Access Compliance Report

Public Rights-of-Way

(Curb Ramps)

Intersection ID: 5500	Main Street: NORTHWOODS_FOREST_DR	Cross Street: SUGAR_HOLLOW_DR	Location: NE
ADA ID: 07AA2F321CAD	Ramp Type: BlendTrans1	Initial Pass/Fail: Fail	Overall Compliance: No
Severity Score: 12.5			
Codes/Mitigation Info/Possible Solution		Field Measurements/Component Compliance

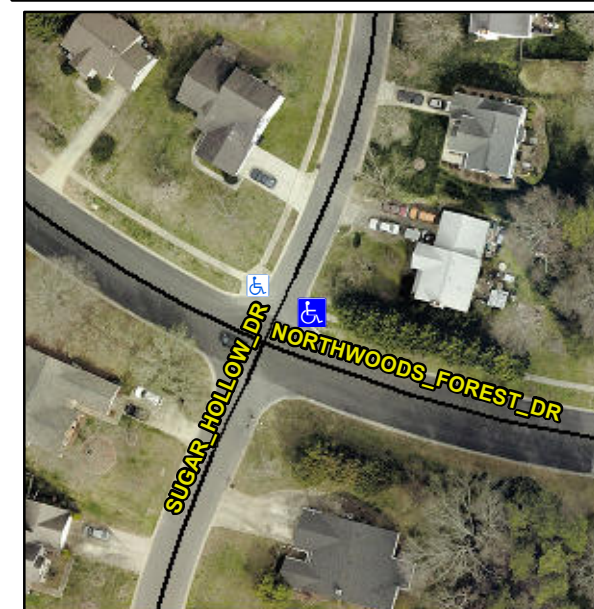
Not Found, R304.5.3

Compliance	Description	Data	Compliance	Description	Data
N/A	Ramp Length (in)	63.0	Yes	BlendTrans Slope (%)	1.1
Yes	Ramp Width (in)	48.0	No	BlendTrans XSlope (%)	5.8
N/A	Flare Type LT	N/A	N/A	Flare Type RT	N/A
N/A	Flare Slope LT (%)	N/A	N/A	Flare Slope RT (%)	N/A
N/A	Flare Traversable LT?	N/A	N/A	Flare Traversable RT?	N/A
N/A	Landing Length (in)	N/A	N/A	DWS Provided?	N/A
N/A	Landing Width (in)	N/A	N/A	DWS Contrast?	N/A
N/A	Landing Slope (%)	N/A	N/A	DWS Length (in)	N/A
N/A	Landing X Slope (%)	N/A	N/A	DWS Full Width?	N/A
N/A	Landing Curb? (Y/N)	N/A	N/A	DWS Offset (in)	N/A
N/A	Shared Landing?	N/A			
N/A	Gutter Ponding?	N/A	N/A	Gutter Slope (%)	N/A
N/A	Gutter Lip Ht (in)	N/A	N/A	Gutter X Slope (%)	N/A
N/A	Painted X Walk1?	No	N/A	Painted X Walk2?	N/A
	X Walk 1 Direction	To NW		X Walk 2 Direction	N/A
	X Walk 1 Width (in)	N/A		X Walk 2 Width (in)	N/A
	X Walk 1 Slope (%)	3.9		X Walk 2 Slope (%)	N/A
	X Walk 1 X Slope (%)	3.8		X Walk 2 X Slope (%)	N/A

N/A	Ramp inside XWalk1?	N/A	N/A	Ramp inside XWalk2?	N/A
	Road Slope (%)	3.8		Clear Space?	N/A
	Road X Slope (%)	3.9	N/A	Clear Space to XWalk (in)	N/A
N/A	Any Obstructions?	N/A	N/A	Storm Grate/Utility Hazard?	N/A
	Obstruction Type			Storm Grate/Utility Type	
		N/A			N/A
			Yes	Surface Condition? (G/P)	Good
			No	Curb Slope (%)	16.2

Remove & Replace Curb Ramp With Two New Directional Ramps or Equivalent.
